3/22/2023 | 6:00 PM

**MUNICIPAL SERVICES CENTER, COUNCIL CHAMBER
3600 TREMONT ROAD**

- a. Review of the February 15, 2023 BZAP meeting minutes.
- b. 2559 Henthorn Road (VAR-09-23) - To allow a two-story addition to encroach up to 1.2 feet into the eight-foot minimum side yard setback.
- c. 1650 Ardwick Road (VAR-10-23) - To allow an attached, enclosed patio to encroach up to 12'-5" into the minimum 32'-5" rear yard setback.
- d. 2380 Northwest Boulevard (VAR-11-23) - To allow a two-story addition to encroach up to 4'-2" into the 10-foot minimum rear yard setback, up to 5'-2" into the rear yard profile, up to 1'-1" into the 10-foot minimum side yard setback, and up to 7'-2" into the side yard longwall setback.

LANDSCAPE/SITE PLAN

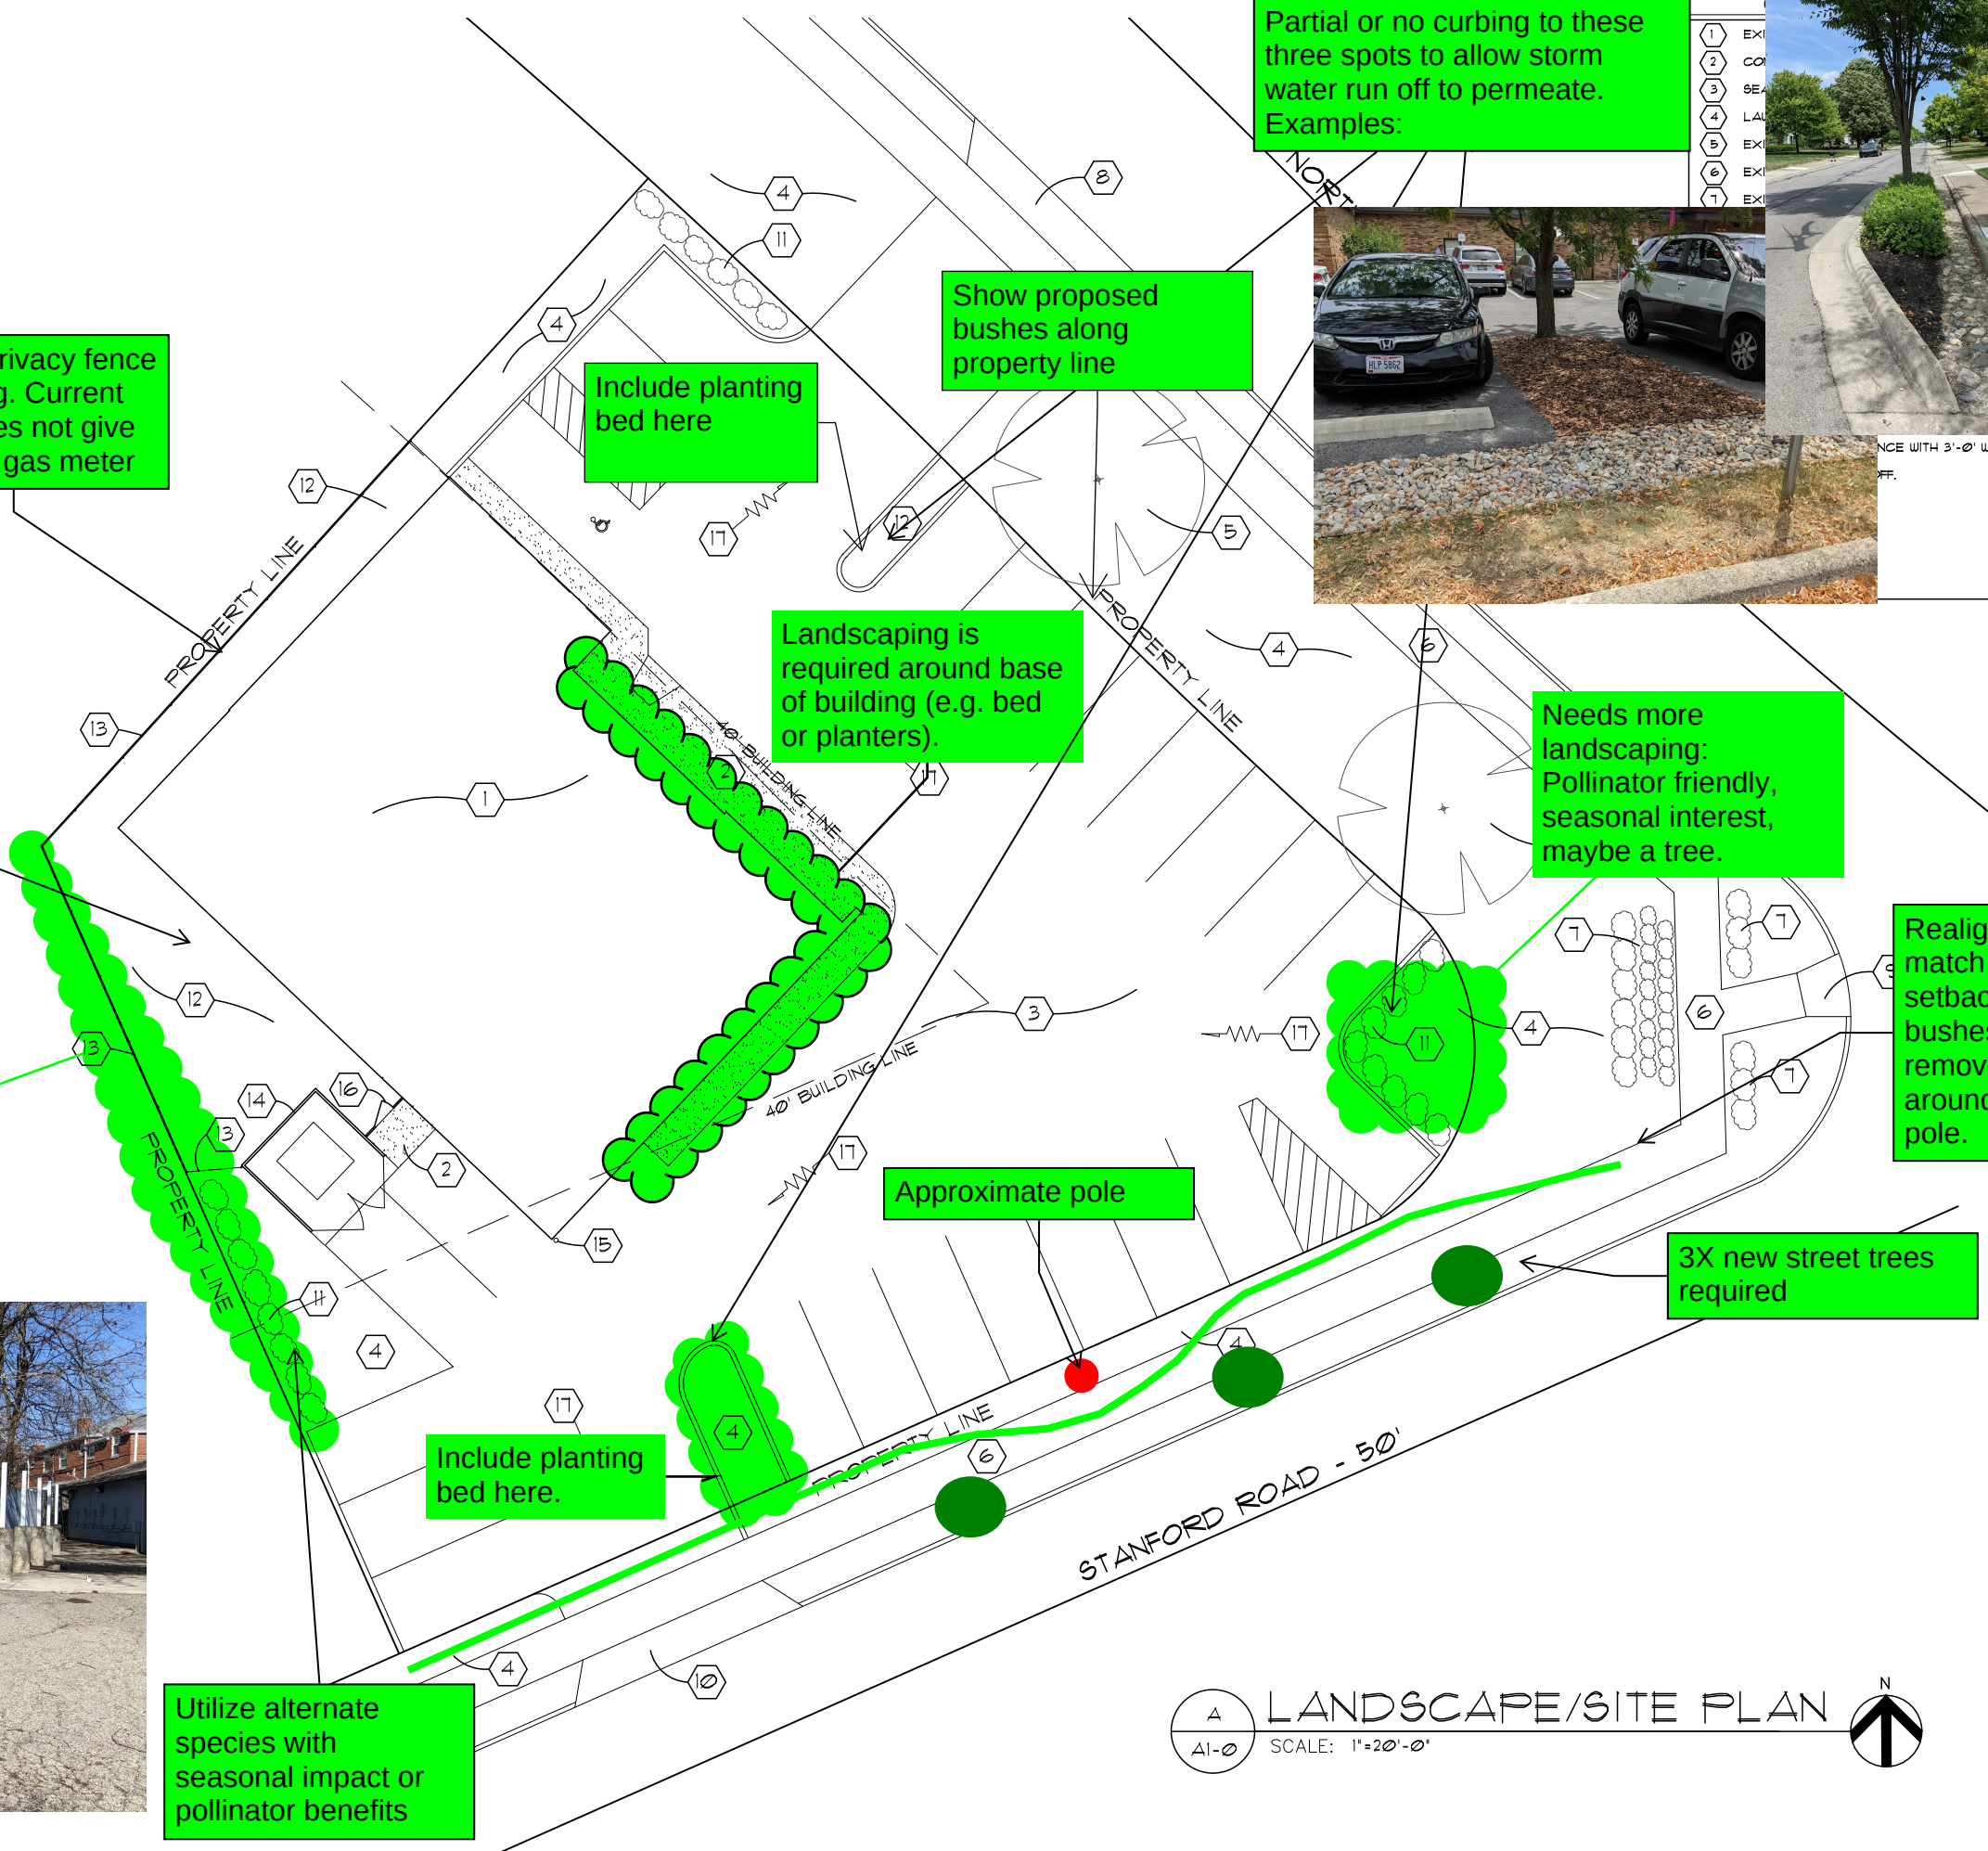
Require privacy fence or planting. Current set up does not give access to gas meter

Indicate where existing cinder block fence is on property (there are two fences that do not line up) and what will be done with it; fix or replace?

DATE
1 MARCH 2023
DRAWING
LANDSCAPE
/SITE PLAN
SHEET NUMBER
A1-0
JLB PROJECT #22012

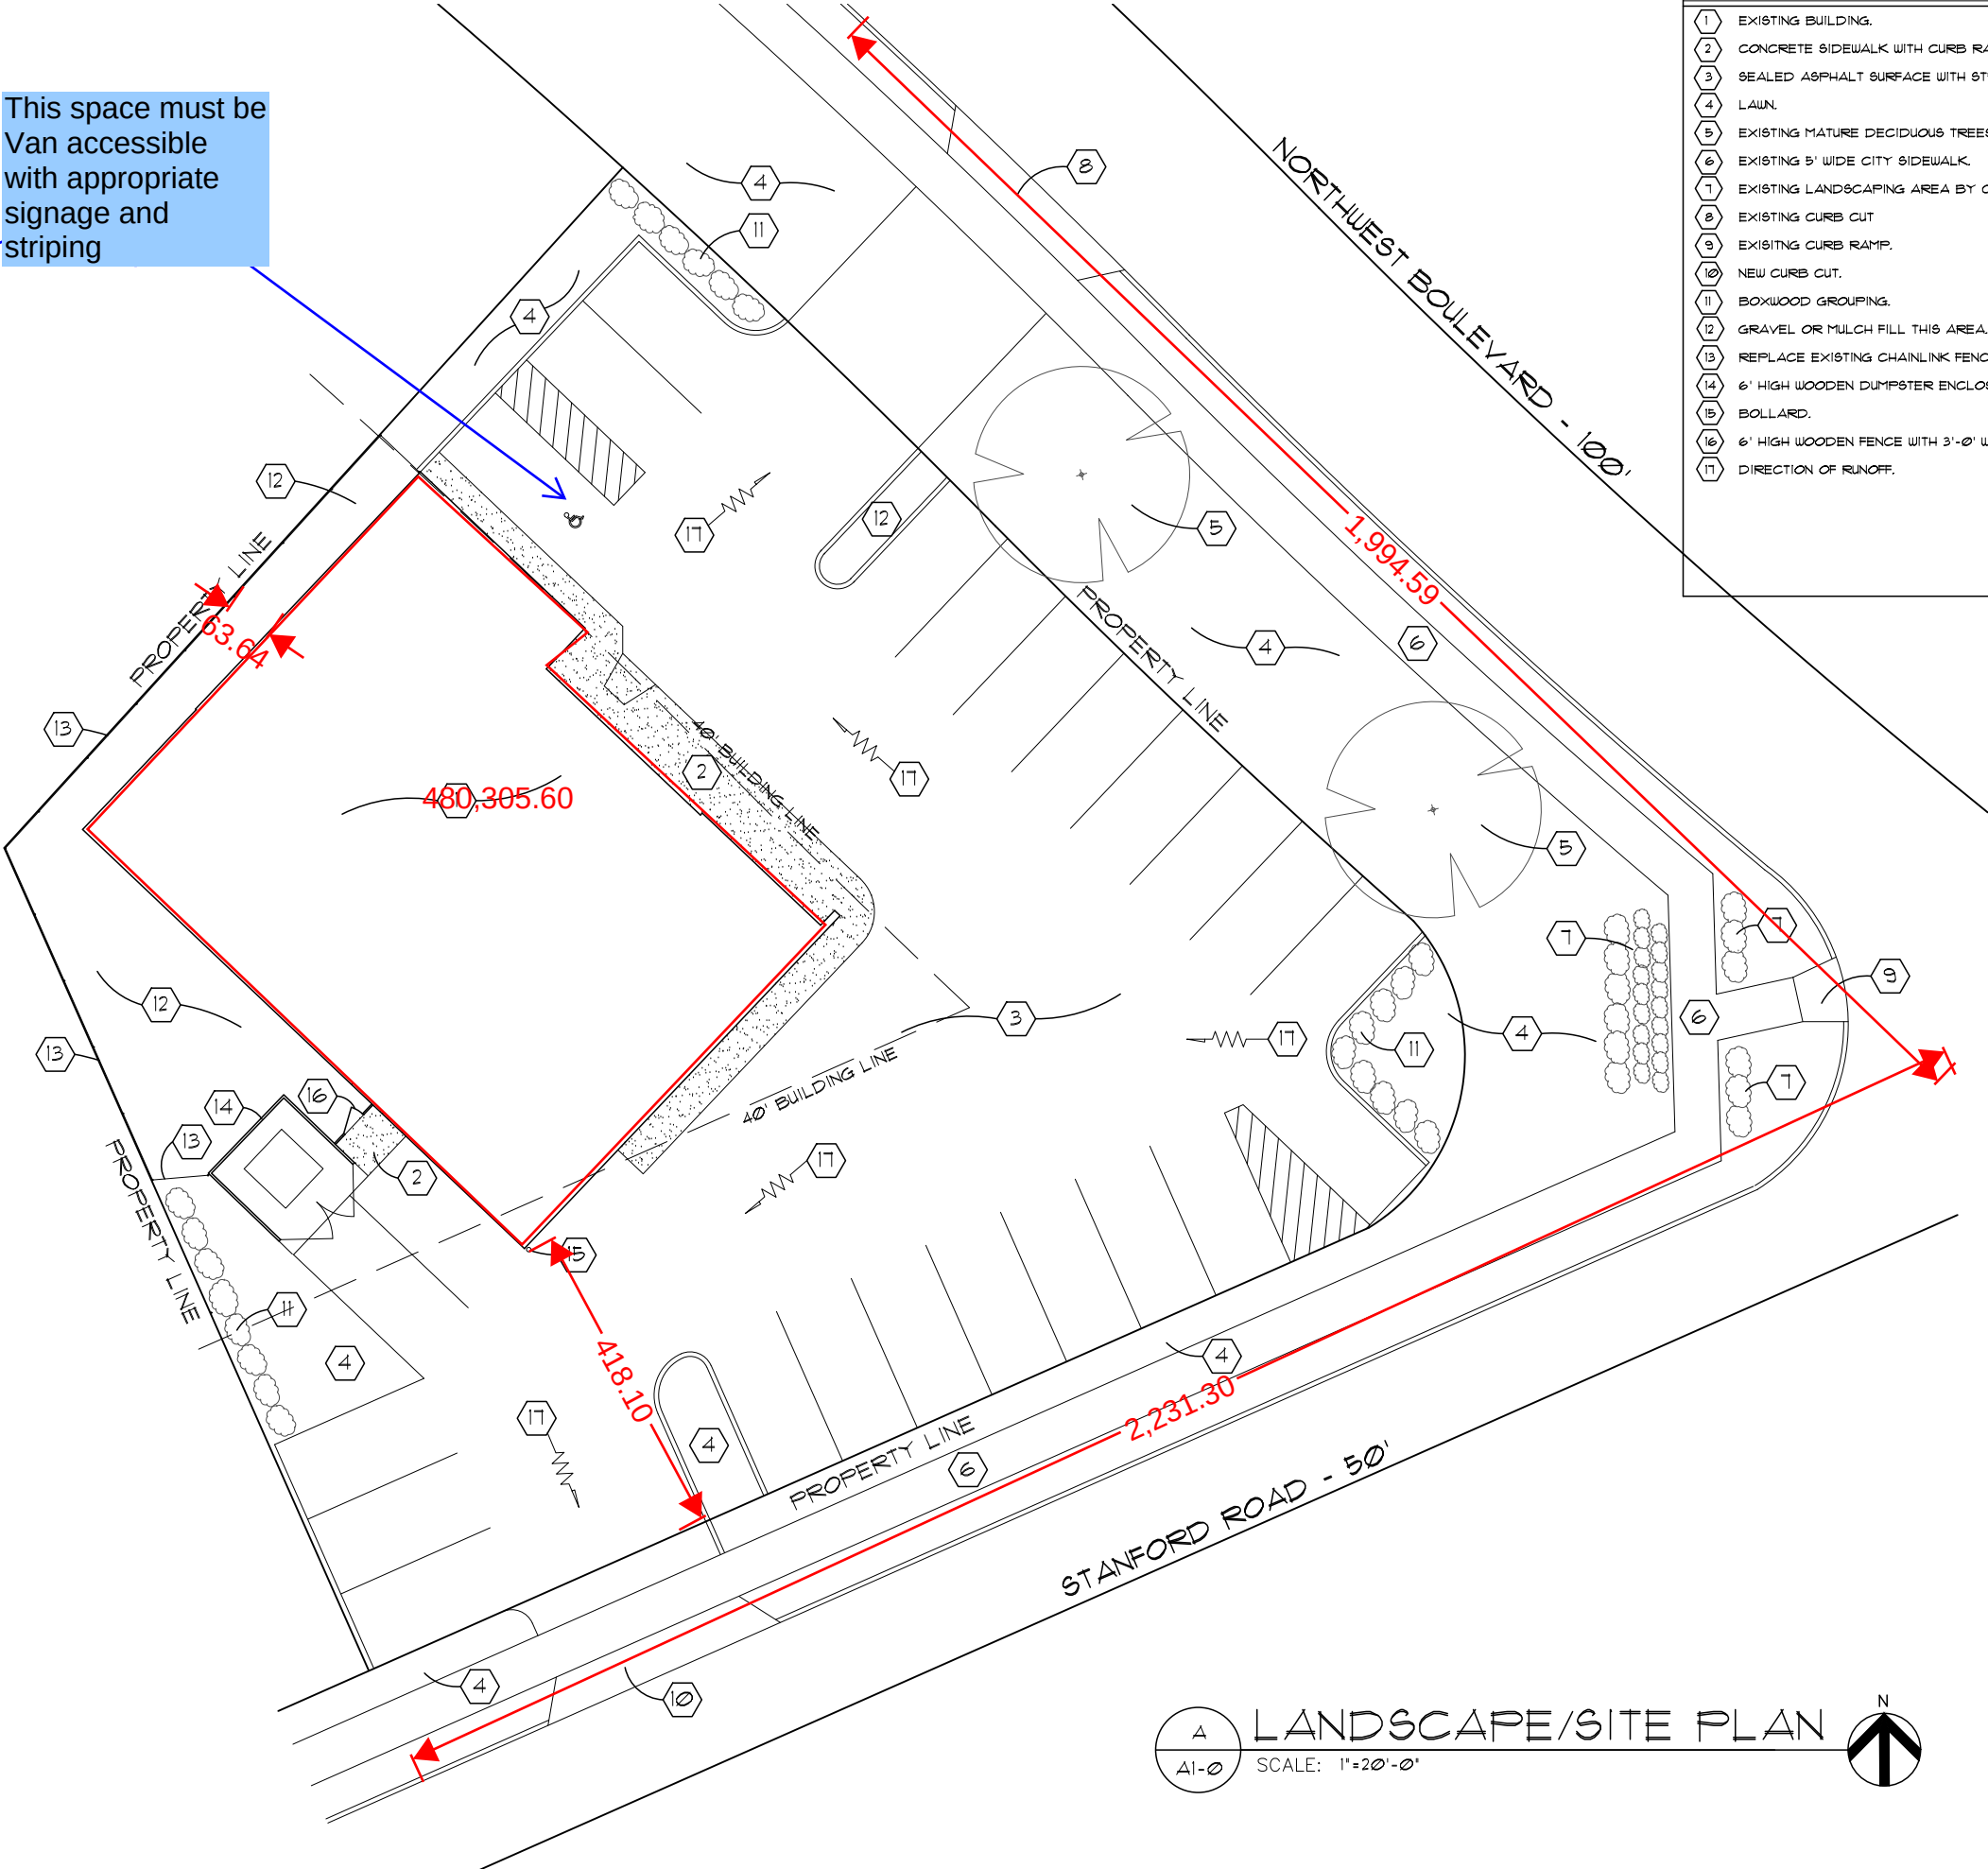
Van accessible spaces must (pick option #1 or #2)

- Be at least 132 inches wide
- Have an access aisle at least 60 inches wide
- Have no more than a 1:48 (2.08%) slope in all directions
- Provide at least 98 inches of vertical clearance (van height) for the parking space, access aisle, and vehicular route
- Have a surface that is firm, stable, and slip-resistant
- Have two signs, mounted at least 60 inches above the ground (measured to the bottom of the sign)
 - First sign: international symbol of accessibility
 - Second sign: stating that the space is van accessible

- Be at least 96 inches wide
- Have an access aisle at least 96 inches wide
- Have no more than a 1.49 (2.08%) slope in all directions
- Provide at least 98 inches of vertical clearance for the parking space, access aisle and vehicular route
- Have a surface that is firm, stable and slip-resistant
- Have two signs, mounted at least 60 inches above the ground (measured to the bottom of the sign)
 - First sign: international symbol of accessibility
 - Second sign: stating that the space is van accessible
